RENESAS TECHNICAL UPDATE

Product Category	Application Specific Standard Product		Document No.	TN-USB-A0005A/E	Rev.	1.00
Title	Notification for additional restriction on usage of SMBus Interface of USB Power Delivery Controller (R9A02G011, R9J02G012)		Information Category	Technical Notification		
Applicable Product	R9A02G011GNP#AC0, R9A02G011GBG#AC0, R9J02G012xxxGBG#AC0	Lot No.	Reference Document	R9A02G011 User's Manual (R19UH0102EJ0230) R9J02G012 User's Manual (R19UH0107EJ0230) R9A02G011/R9J02G012 Application Note (R19AN0062EJ0150)

1. Issue overview

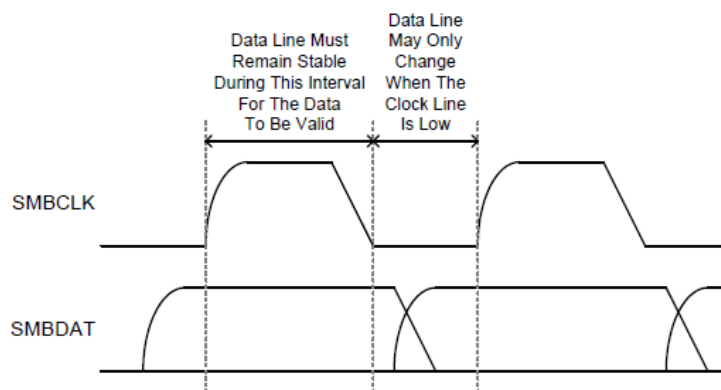
When SMBus master reads the R9A02G011/R9J02G012's SMBus Slave Port and the master's ACK response to the R9A02G011/R9J02G012's Read Data takes more than 43 μ s, next Read Data will be corrupted to 0xFF. The issue will happen with any SMBus clock speed of Word or Block Read transaction.

The issue will happen during Word or Block Read transaction. The R9A02G011/R9J02G012 has a function to count a length of SCL low period. But it misunderstands it receives the NACK when the SCL low period is longer than 43 μ s and terminates the Read Transaction.

The SCL is kept low at that point and the SDA may be invalid. So that the R9A02G011/R9J02G012 as I2C/SMBus slave shall not sample the SDA at that point and shall not determine if it receives ACK or NACK.

- I. When SMBus master performs Word Read or Block Read, SMBus master shall respond ACK/NACK within 40 μ s for each read data.
- II. Modify the SMBus slave ALTER register from Read Clear to Write Clear so that when the bug occurs, the SMBus master will discard the erroneous data and re-read the register.
